RULE NO.: R161-19.22

NOTICE OF RULE ADOPTION

R161-19.22: Revises the Drainage Criteria Manual as follows:

Example 1 Vertical Clearance (Profile View; not to scale)

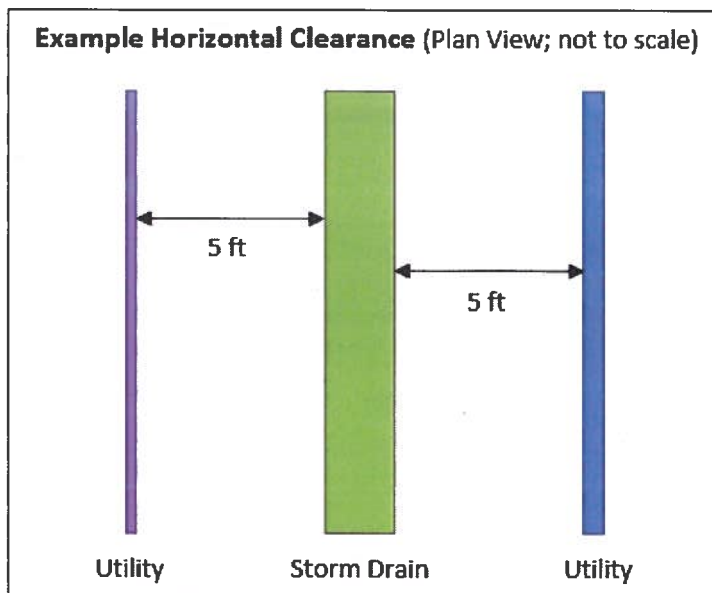
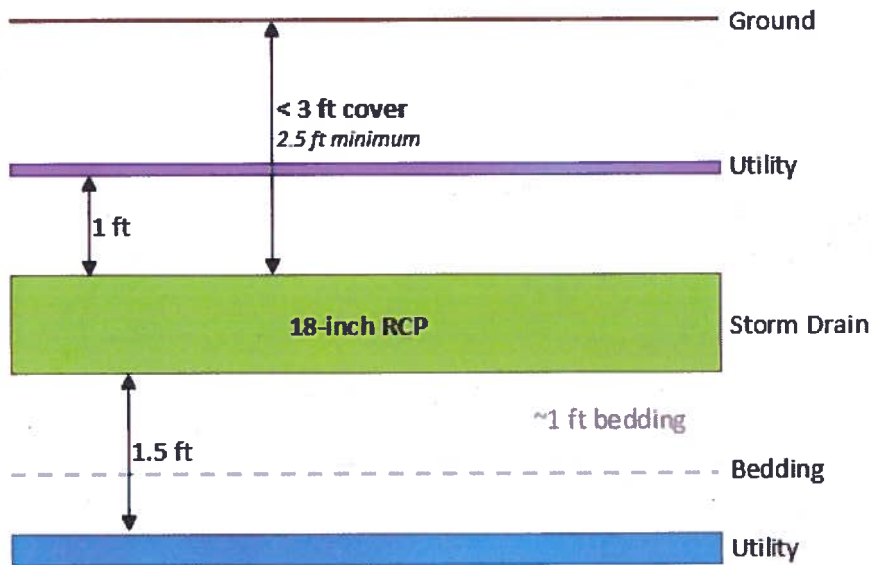
“ACEA protests the inclusion of Section 5.7.1 regarding clearance between storm and other subsurface utilities in the WPD Q4 FY 2019 Rules as posted.

Austin Water also disagrees that the clearances required are sustainable without pushing water and wastewater piping so deep that they are unnecessarily costly to maintain. AW and WPD have reached a temporary compromise regarding dispensation from following the clearance requirements as allowed by each utility, but this will cause an unpredictable case-by-case application of what should be a clear-cut minimum vertical clearance.

The overarching goal should be to make all subsurface piped utilities as shallow as safely possible. AW and WPD both routinely complain about deep lines. The proposed excessive clearances only make lines deeper.

Furthermore, we take issue with the Affordability Impact Statement (AIS) claim that increasing vertical clearance between pipes is cost neutral. Depending on soil conditions, the average cost per foot of extra depth is \$2-\$4 per linear foot for typical 8-inch water and wastewater lines. Section 5.7.1 was not even considered in the AIS determination, downplaying the negative impact to affordability.

ACEA requests that the above section of the revised rules be removed from this posting and tabled until another rule revision after AW, WPD, franchise utilities, and other external stakeholders can agree on reasonable minimum clearances. ACEA would like to assist with the negotiation between the departments.”

Inclusion of the proposed DCM Section 5.7.1 separation language is necessary to have a code/criteria citation since none exists for stormdrain infrastructure currently. The two main reasons that WPD wants higher vertical clearance requirements than what Austin Water proposes (12” above and 18” below) for large and deep pipes are as follows:

1. Future maintenance of storm drain pipes. Storm drain pipes are generally larger than water and waste water lines requiring larger equipment, which needs larger clearance, and;
2. The 2018 update of Atlas 14 resulted in an increase in rainfall depths over most of the Austin metropolitan area. Thus, the replacement storm drain infrastructure will be larger than existing pipes. WPD needs the proposed clearance space available for future storm drain pipe replacement.

Additionally, current AULCC guidance requests 2-ft vertical in all instances (WPD & AW), the proposed DCM language allows more flexibility and generally requires less vertical clearance.

AW and WPD reached agreement on the vertical separation language by adding language in DCM Section 5.7.1.K. WPD received explicit agreement from AW to post this section after the inclusion of the language in K. Items J & K allow less vertical without a waiver. WPD has offered to further revise 5.7.1 in Q2 FY 2020.
